## **NOTICE OF PUBLIC MEETING**

**Governmental Body: Van Meter Planning and Zoning Commission**

VAN METER, IOWA  
GRAND RIDGE ESTATES TOWNHOMES  
PRELIMINARY PLAT/SITE PLAN  
REVIEW COMMENTS

**RE: Grand Ridge Estates Townhomes Plat 1 – Preliminary Plat / Site Plan**

**GRADING PLAN**

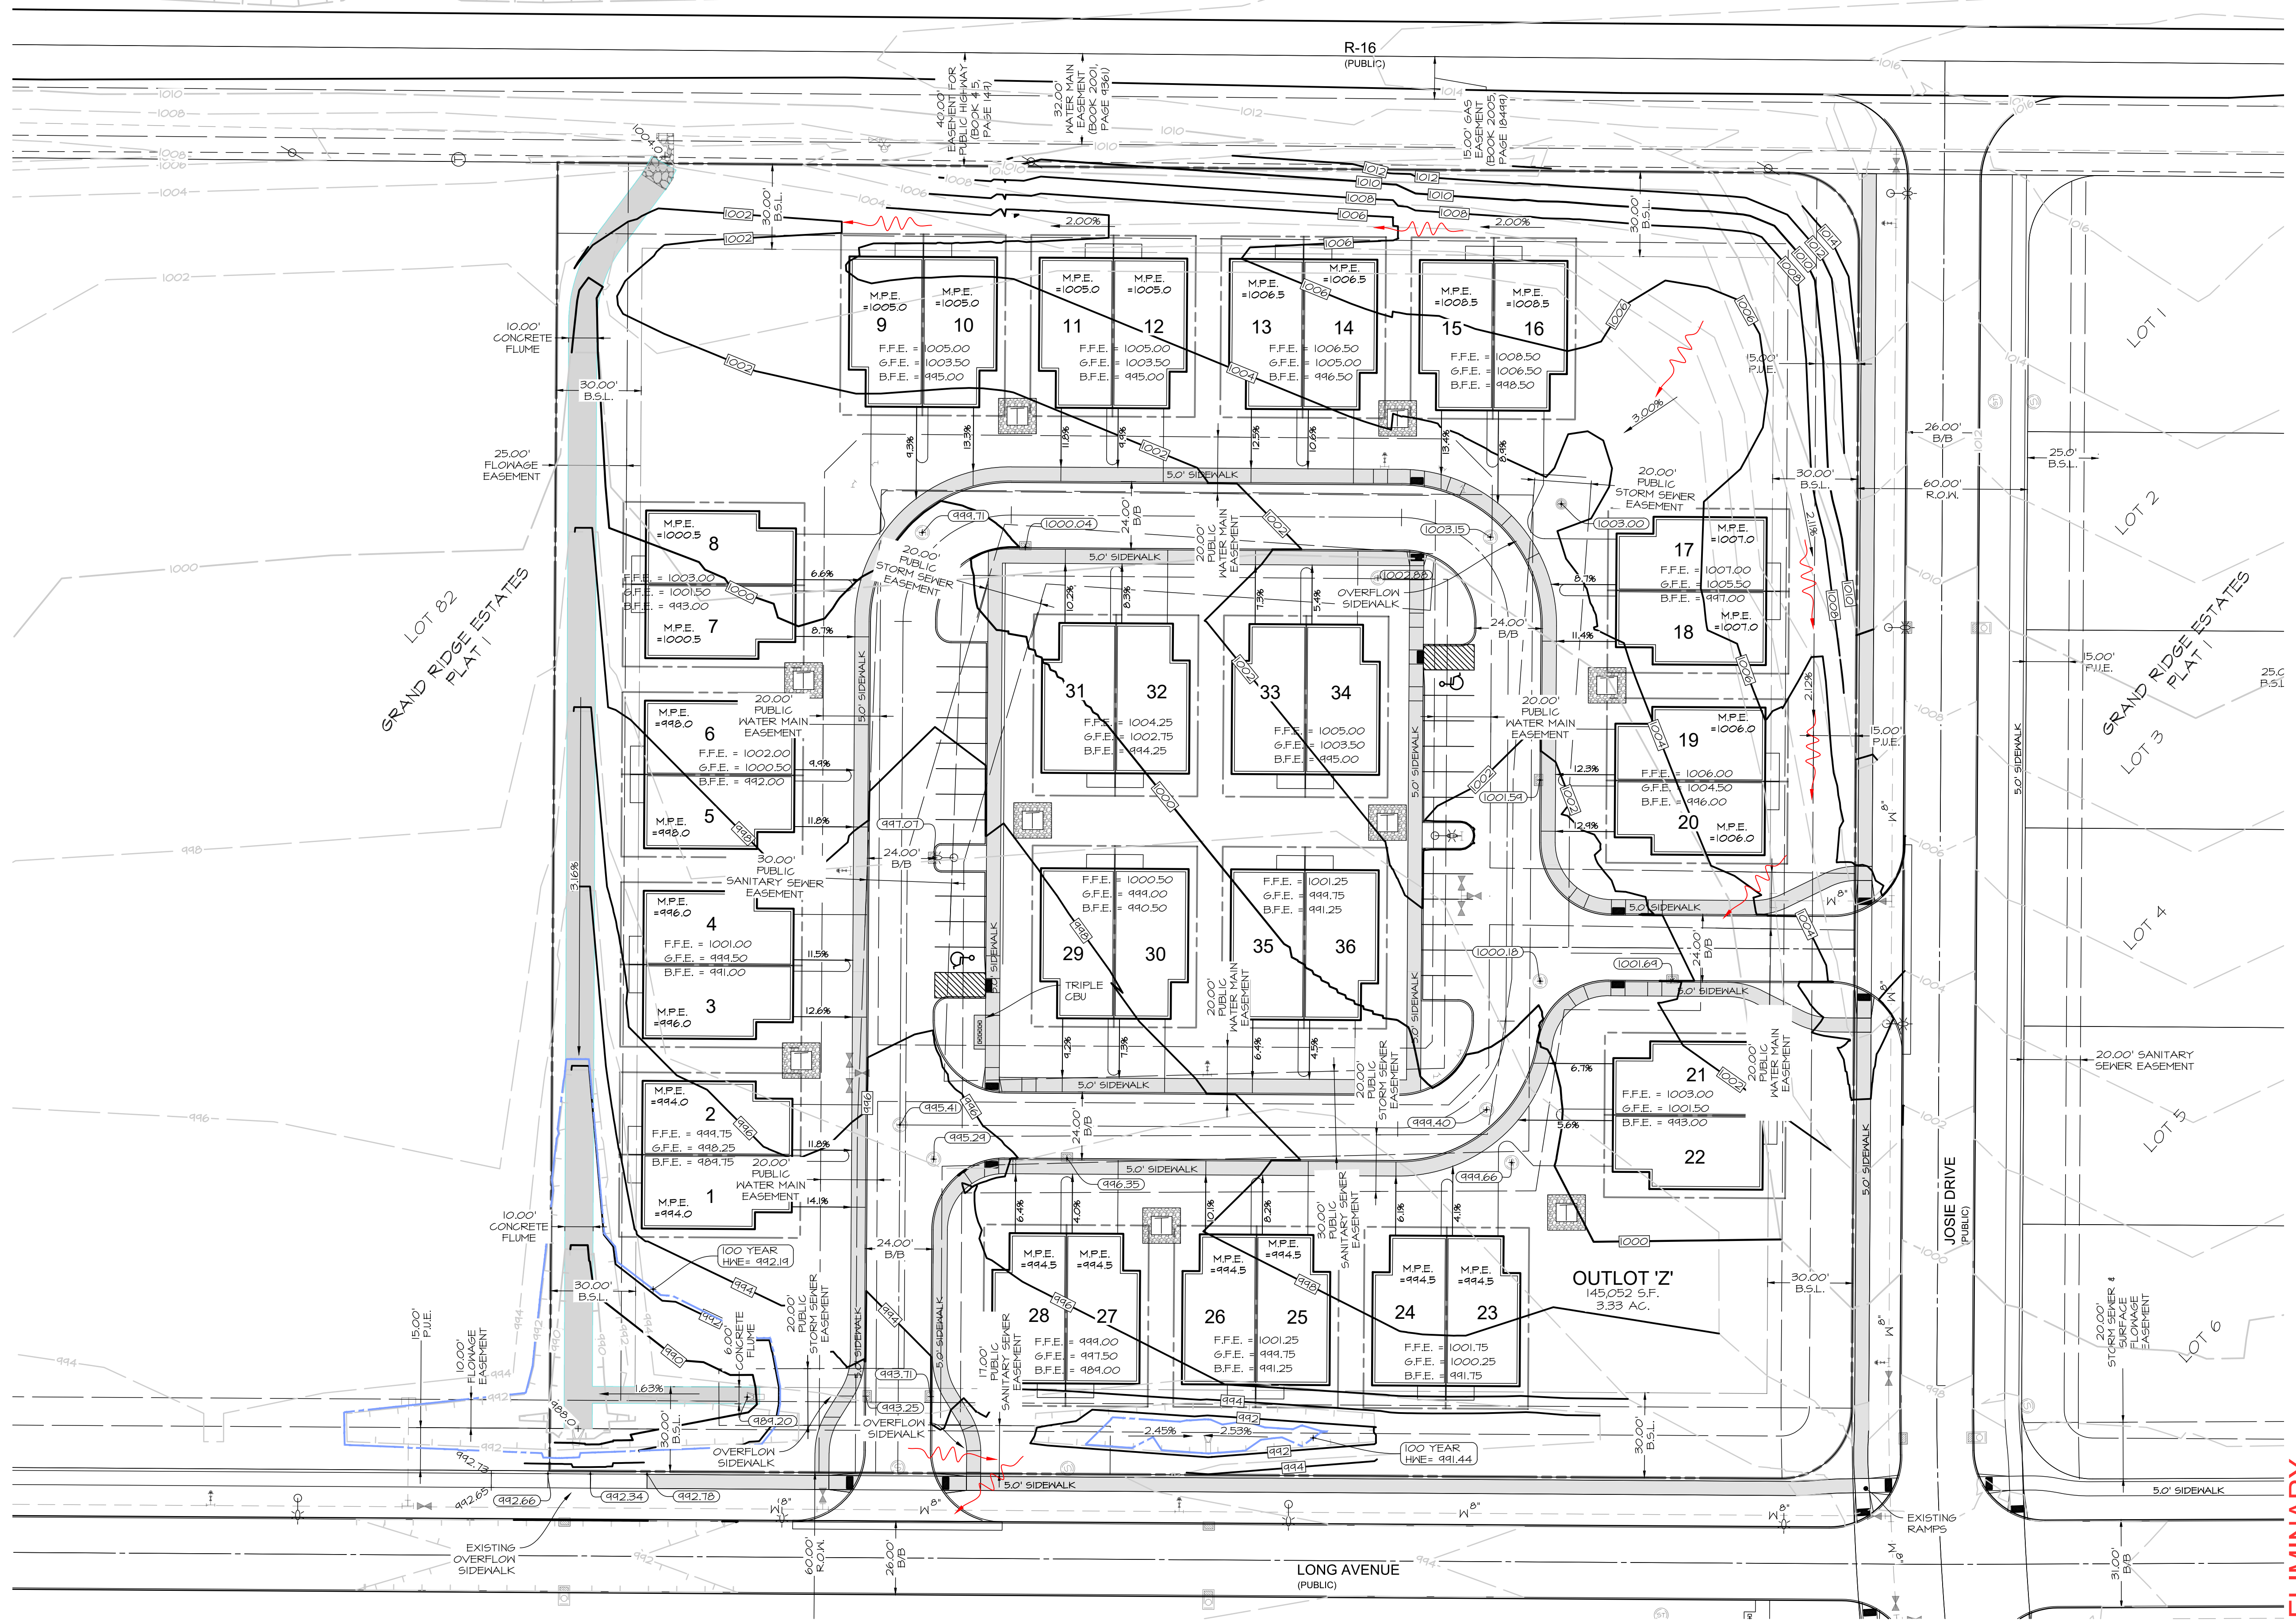
31. The water main is shown to be public.
32. The site grading plan generally shows the site to drain from the northeast to the southwest.
33. Based on the site grading plan there will be several locations where the water flow will be diagonally across the orientation of townhome units. During the individual site development it will be necessary to ensure the runoff is routed around the bi-attached townhome units.

34. The site plan includes minimum protection elevations (MPE) on Lots 1 through 20 and Lots 23 through 28 located along the perimeter of the project. No MPEs are shown on Lots 21 and 22 on the perimeter and Lots 29 through 36 located in the interior of the looped street.

30. Valves have been added on all three legs of the water main of the two internal tees to provide enhanced reliability of the water system. The additional valve locations are satisfactory.
34. MPE elevations are now shown for all lots.

33. Based on the site grading plan there will be several locations where the water flow will be diagonally across the orientation of townhome units. During the individual site development it will be necessary to ensure the runoff is routed around the bi-attached townhome units. **OK**
34. The site plan includes minimum protection elevations (MPE) on Lots 1 through 20 and Lots 23 through 28 located along the perimeter of the project. No MPEs are shown on Lots 21 and 22 on the perimeter and Lots 29 through 36 located in the interior of the looped street. **The grading plan and M.P.E.s have been revised.**
